HERBATA DATA CENTRE, NAAS-RESPONSE TO REQUEST FOR FURTHER INFORMATION ("RESPONSE TO RFI") FROM KILDARE COUNTY COUNCIL

ADDENDUM TO CHAPTER 10 CULTURAL HERITAGE

NI2615
01
June 2025

Figure 10.3: Amended Layout Illustrating DC4 Layout with Geophys Data Overlay (extract of now submitted drawing 22217-RKD-ZZ-ZZ-DR-A-1012-PROPOSED SITE PLAN B)

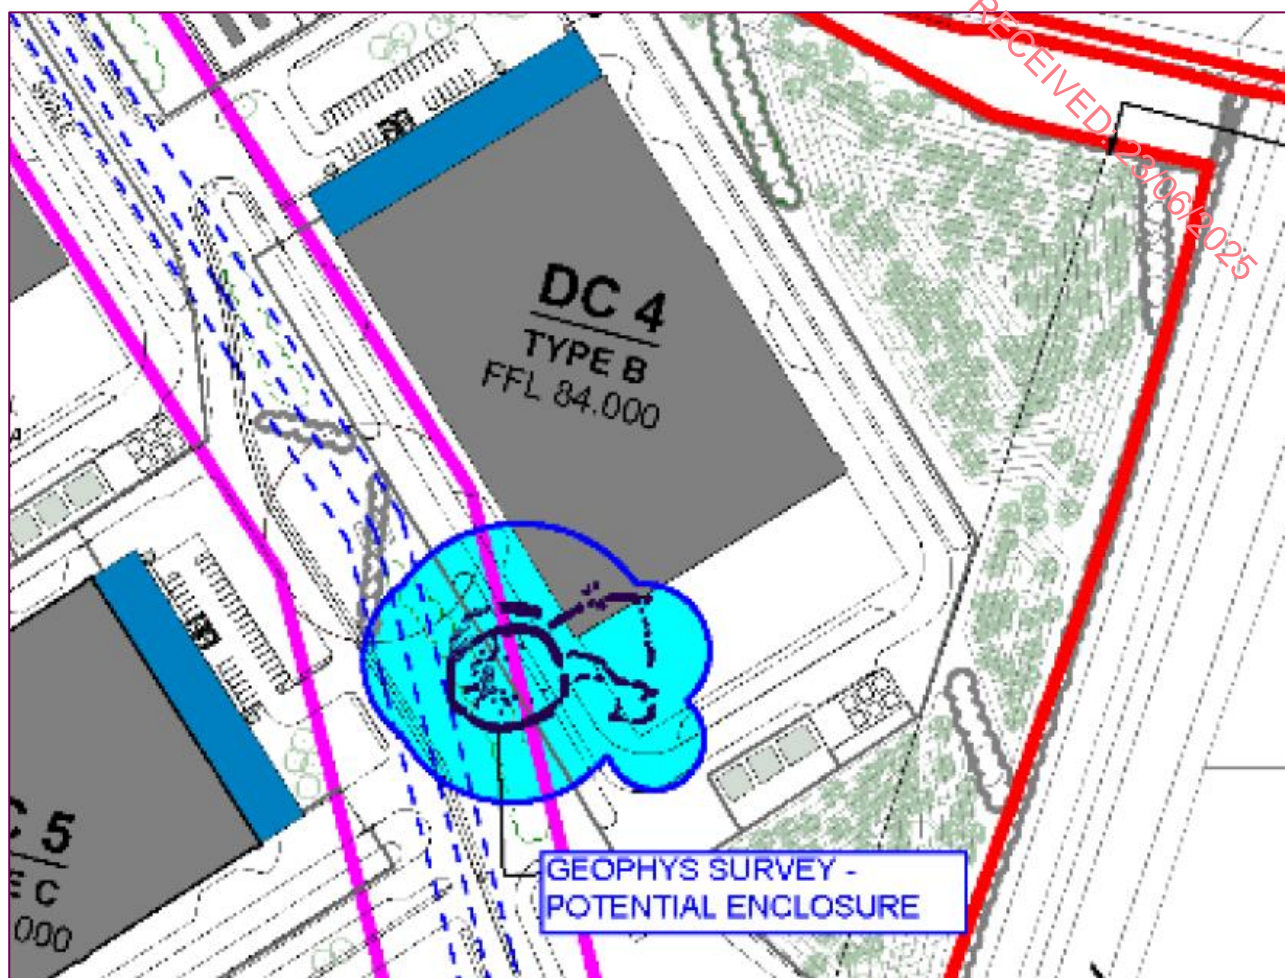
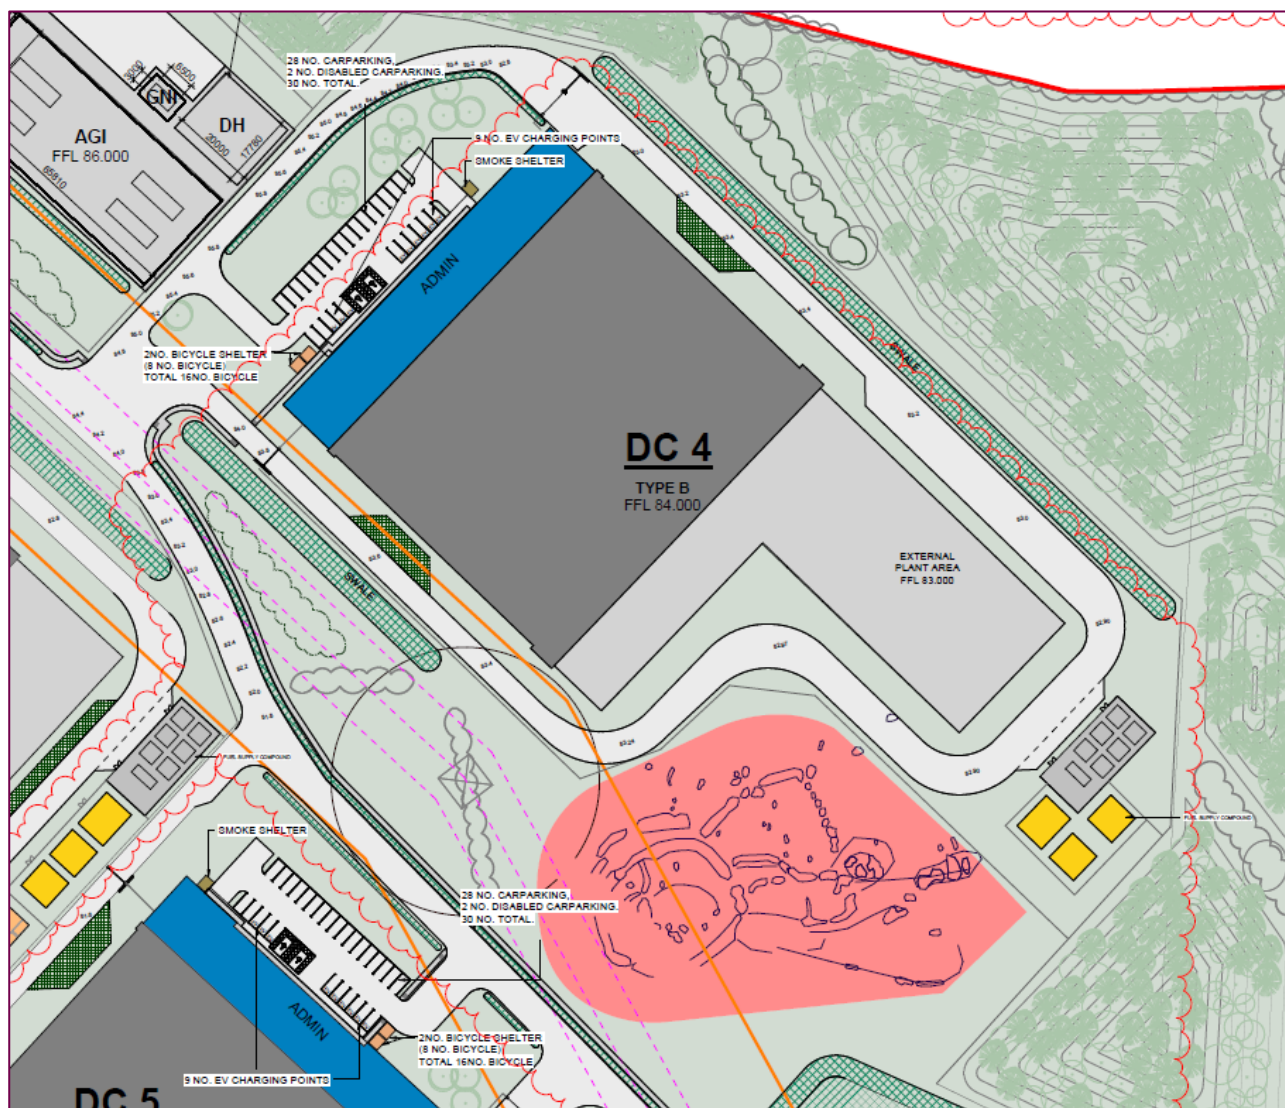
25. Given the scale and location of the development site, it is possible that previously unrecorded sub-surface archaeological remains could be disturbed during the course of groundworks required for the development. The extensive area of archaeological significance identified through geophysical survey within Field No. 8 is considered to represent a new archaeological monument and preservation in situ should be the first and preferred first option. In accordance with Section 3.4 of Framework and Principles for the Protection of the Archaeological Heritage (1999), the Applicant is requested to conduct a comprehensive interrogation of design options to determine the feasibility of facilitating preservation in situ of this monument and submit a detailed report detailing the results of an assessment of all design options.

The submitted design involved encroachment of the southern portion of Date Centre 4 and its external ancillary elements, such as a swale and access road, into the area containing the enclosure feature identified during geophysical survey (referred to as 'new archaeological monument' in the RFI from Kildare County Council).

The Kildare County Council RFI (Item 25) requested a *comprehensive interrogation of design options to determine the feasibility of facilitating preservation in situ of this monument and submit a detailed report detailing the results of an assessment of all design options.*

The amended layout of Data Centre 4 will allow for the preservation of the enclosure feature which comprises of a circular ditched feature (c.31m diam.) with multiple internal features and two sub-rectilinear annexes, extending c.25m to the east of the main enclosure *in situ*. The proposed amendment to Data Centre 4

The area preserved in situ is surrounded by a 10m exclusion zone extending from the outer edge of the identified enclosure feature. This exclusion zone shall be fenced-off and remain an exclusion zone throughout both the construction phase and operational phase of the project (a cross section illustrating the exclusion zone is provided in drawing 2232-DOB-ZZ-ZZ-DR-C-0600, Proposed Site Sections, Vol III).

The most notable amendment is to the overall building shape of Data Centre 4, however due consideration has been given to all built elements within the locale of the enclosure feature, in order to ensure that drainage and road infrastructure, external plant compounds, security fencing, landscaping and temporary construction compounds, remain outside the exclusion zone.

For the purpose of comparison (to Figure 10.2 above), Figure 10.3 illustrates the amended proposed layout detail for Data Centre 4 respectively, as relative to the enclosure feature.

Figure 10.4: Cross Section Illustrating Archaeological Exclusion Zone (extract of now submitted Drawing 2232-DOB-ZZ-ZZ-DR-C-0600)

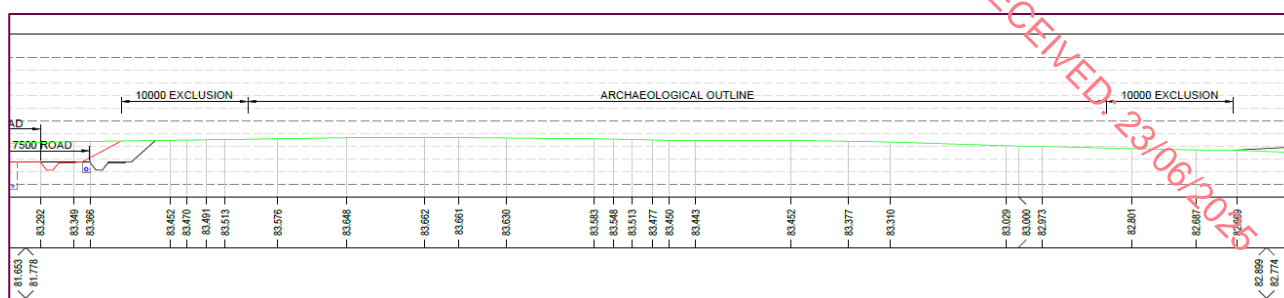
By way of a cross section, Figure 10.4 below illustrates the implementation of the exclusion zone relative to adjacent service roads.
